# Assessment of revised Contributions Plan 15 for Box Hill

**The Hills Shire Council**

**Final Report  
Local Government**

**October 2018**

**Figure 5.1 Box Hill Precinct road network**

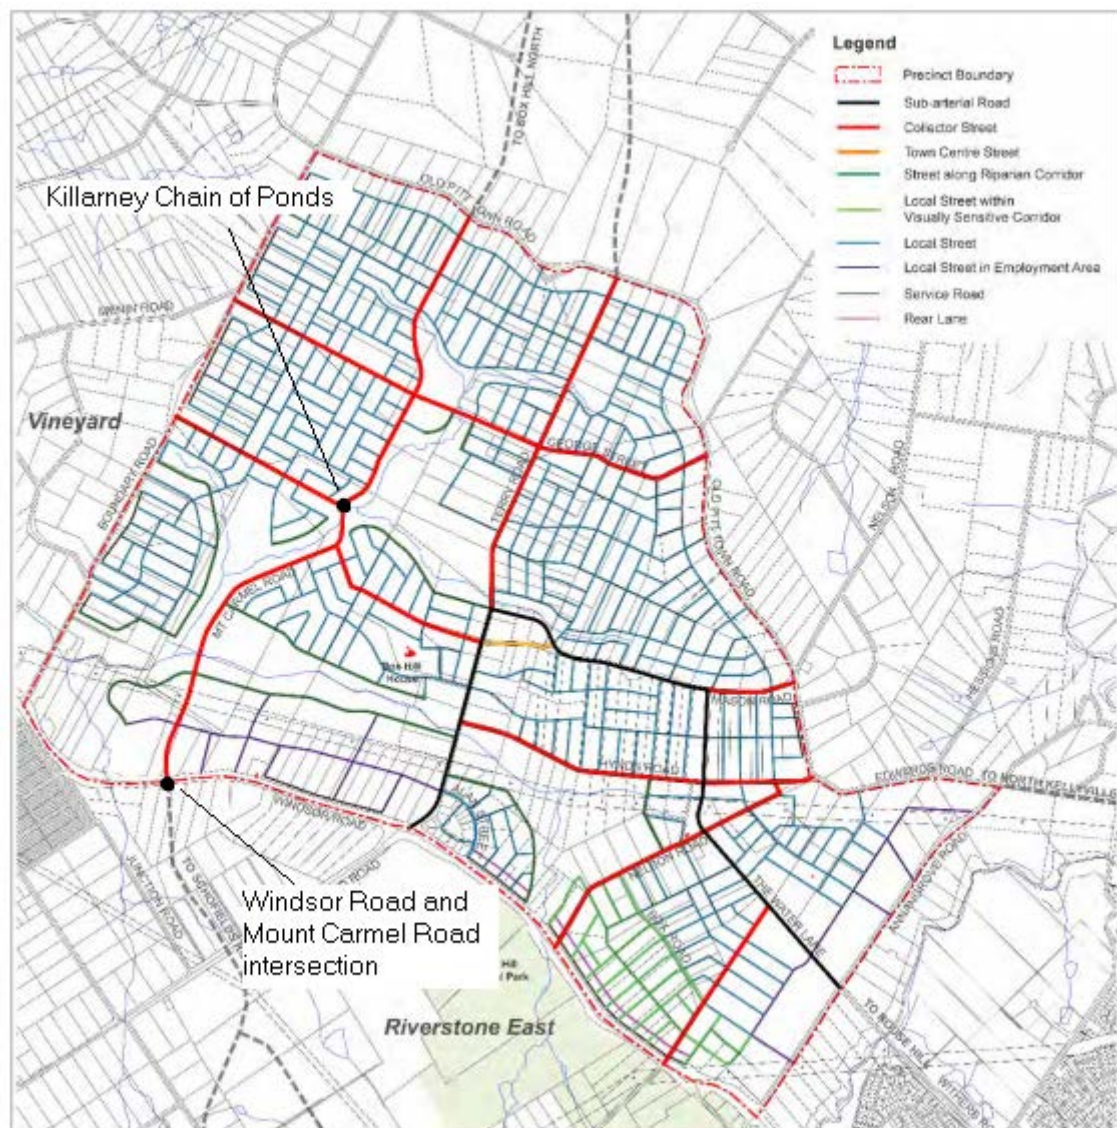
The DCP identifies the entire length of Mount Carmel Road between Windsor Road and Old Pitt Town Road as a collector road (see Figure 5.1). However, the DCP also specifies the collector road requirements of the section of Mount Carmel Road between Windsor Road and Killarney Chain of Ponds as having an additional median and carriageway to accommodate traffic flows (see Figure 5.2).

Brown Consulting has assumed traffic flows for Mount Carmel Road to carry up to 21,960 vehicles per day indicating that it will operate towards the upper notional limit of a sub-arterial road.<sup>42</sup> Furthermore, the road layout in Figure 5.2 indicates that Mount Carmel Road will have a width of 30 metres, which is wider than other typical collector roads (19.6 metres) and sub-arterial roads (25.7 metres).<sup>43</sup>
